**SUSQUEHANNA STEAM ELECTRIC STATION  
SUPPLEMENTAL INFORMATION FOR  
PROPOSED RELIEF REQUESTS NO. 29 AND 30 TO THE  
SECOND 10-YEAR INSERVICE INSPECTION PROGRAM  
FOR SUSQUEHANNA SES UNIT 1  
PLA-5743**

**SUPPLEMENTAL INFORMATION IN  
SUPPORT OF  
RELIEF REQUESTS NO. RR-29 AND 30**

**PPL SUSQUEHANNA, LLC  
SUSQUEHANNA SES UNIT 1  
SECOND 10-YEAR INTERVAL  
SUPPLEMENTAL INFORMATION  
IN SUPPORT OF RELIEF REQUEST NO. RR-29 AND 30**

**Sketch #1**  
**N1B Nozzle and Weld**  
**Overlay Configurations**

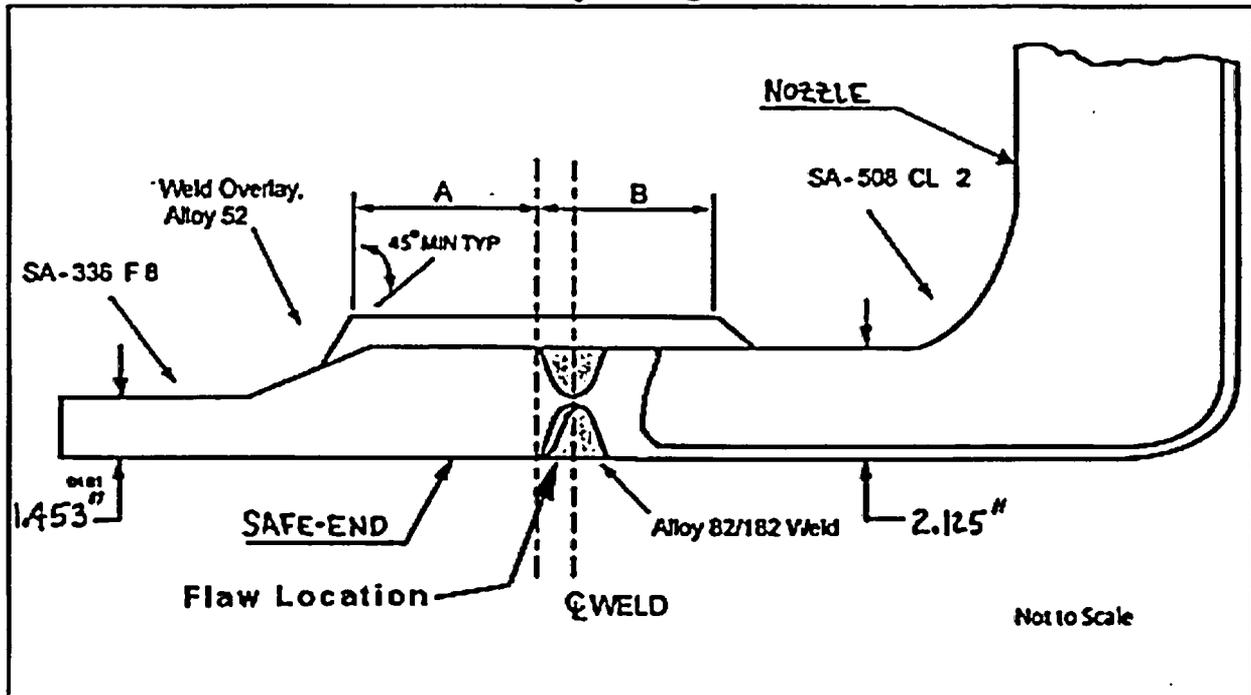
Provide a sketch of the original weld and base metal configuration and final weld and base metal configuration with the overlay?

Nozzle	2.125 inches
Pipe	1.453 inches
Original 182 butter	See Sketch # 2 in Attachment 1
Final overlay weld	0.74 inch

The original weld and base metal configuration is shown in the attached Sketch #2. For the final weld and base metal configuration with the overlay, see the attached Sketch #1. These sketches are included in Attachment 1.

## Sketch #2 N1B Nozzle Weld Prep (Original Configuration)

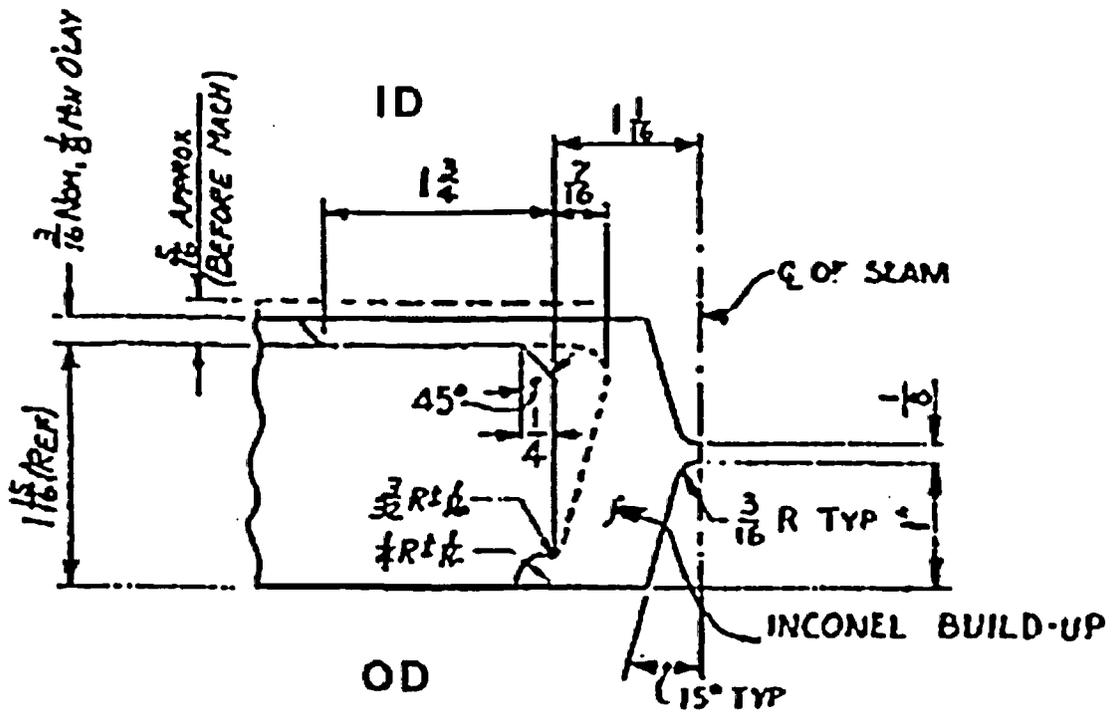
What are the thickness of the nozzle, pipe, original ASME II material classification 182 butter, and final weld overlay?

**Figure 1**  
**45 Degree RL Data from 1992 (Prior to MSIP did not see indication due to lack of contact)**

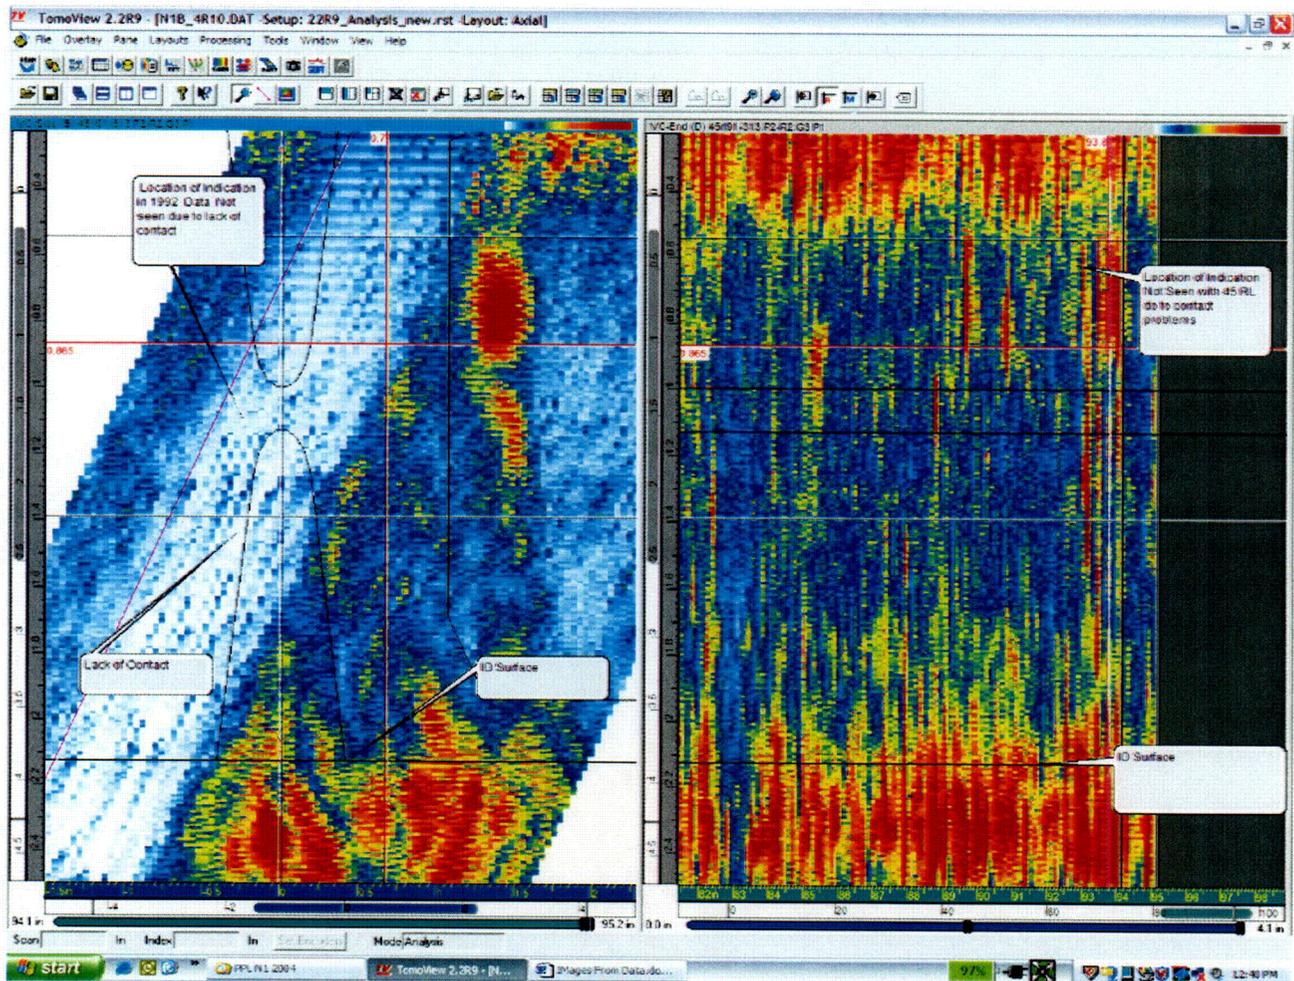
In EPRI summary report dated March 26, 2004, the reason that the flaw indication was not detected using a reflective longitudinal (RL) 45-degree probe in earlier examinations was attributed to lack of contact. However, the indication was identified in Figure 7 based on 2004 data using 45 degree RL probe. Please explain.

It is believe that the 45 degree data from the previous examinations did not have sufficient contact due to loss of couplant or incorrect pressure applied to the search unit to keep it coupled to the surface. This condition was not obvious to examiners when using the older data analysis software. When using the new data analysis software, this type of condition is easy to detect and thus easy to make appropriate adjustments to correct the condition. The data collected in the 2004 examination with the 45 RL search unit has very good contact.
